**Docket:** NRC-2019-0113

Guidance for a Technology-Inclusive, Risk-Informed, and Performance-Based Methodology to Inform the Licensing Basis and Content of Applications for Licenses, Certifications, and Approvals for Non-Light Water Reactors

# **Review Comments on Draft Regulatory Guide DG-1353, Guidance for a Technology-Inclusive, Risk-Informed Methodology to Inform the Licensing Basis and Content of Applications for Certifications and Approvals for Non-Light Water Reactors**

Figure 1. Frequency-Consequence Curve Interpreted as a Limit on the Complementary Cumulative Distribution Function for Licensing Basis Events

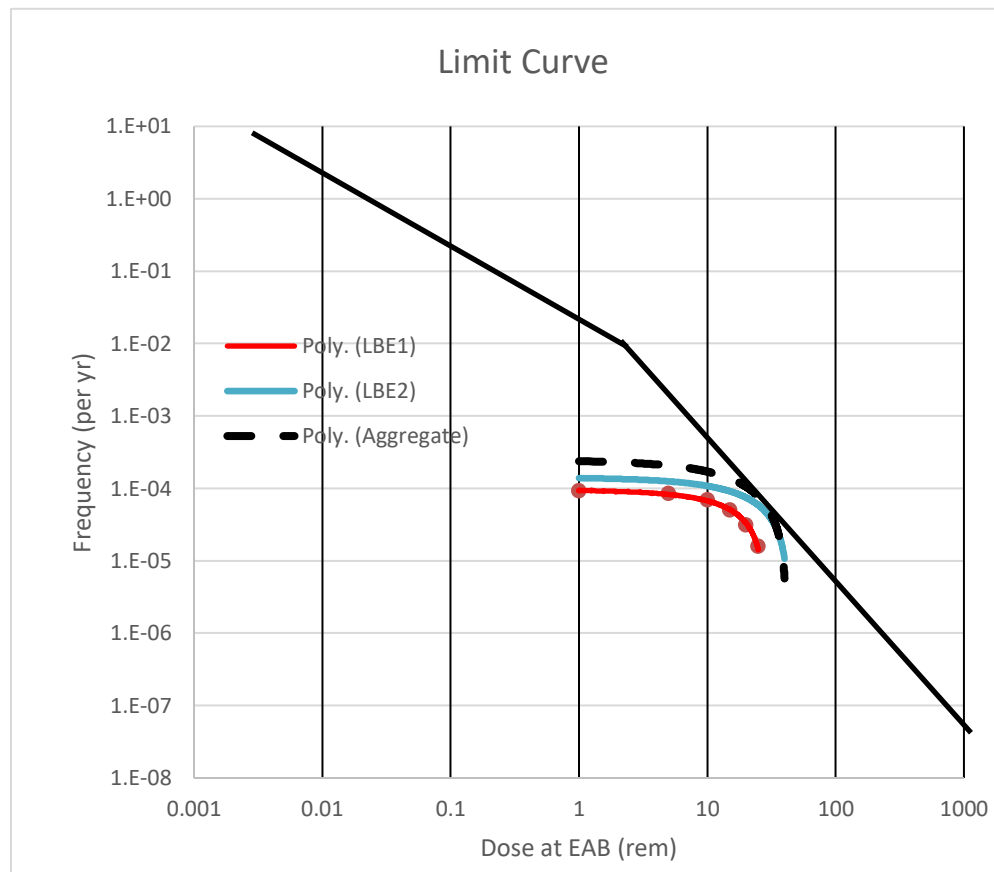
For the DBE and BDBE range we use a slope of -2. The result is shown in Figure 1. In this case the risk contribution from DBEs is determined to be less than  $1.5E-4$  rem/yr approximately 15 percent of the risk from AOOs. The CCDF limit at 1000 rem is  $5E-8$ /yr, which is more restrictive than the early fatality probabilistic safety goal. The 25 rem dose occurs at  $7.5E-5$  per yr, which is approximately at the lower bound of the DBE region. The shape of this Frequency-Consequence curve is very similar to the curve in NEI 18-04 other than the low consequence region for which the NEI curve has a discontinuity at the boundary between AOOs and DBEs, which does not exist in the curve we developed. The principal difference is in the interpretation of the curve.

Also shown in the figure are CCDFs for two hypothetical Licensing Basis Events (LBEs) based on uncertainty distributions, as could be developed from best-estimate plus uncertainty analyses. Within the context of NEI 18-04, each LBE would be considered separately. In the proposed reinterpretation of the Frequency-Consequence curve the aggregated CCDF would be required to fall to the left (below) of the curve to satisfy the intended risk constraint. An importance measure has been developed previously to

assess the proximity of a scenario to a limit curve, referred to as a Limit Exceedance Factor [5]. For the example demonstrated, the aggregated CCDF contacts the limit curve, even though the individual CCDFs satisfy the criterion. Whether a 95% uncertainty limit should be added to provide margin to the limit curve is a policy decision that requires discussion. It is our suggestion that the shape of the CCDF for an event would be determined based on aleatory variability and that epistemic uncertainties would be treated as margin on the frequencies and consequences of LBEs.

Within the context of the CCDF interpretation of the Farmer Curve, LBEs would be treated individually as in the NEI 18-04 interpretation, as a necessary condition. However, consideration would be required of the aggregated LBEs if the results would approach the limit curve and the LBEs cover the same region of the limit curve.
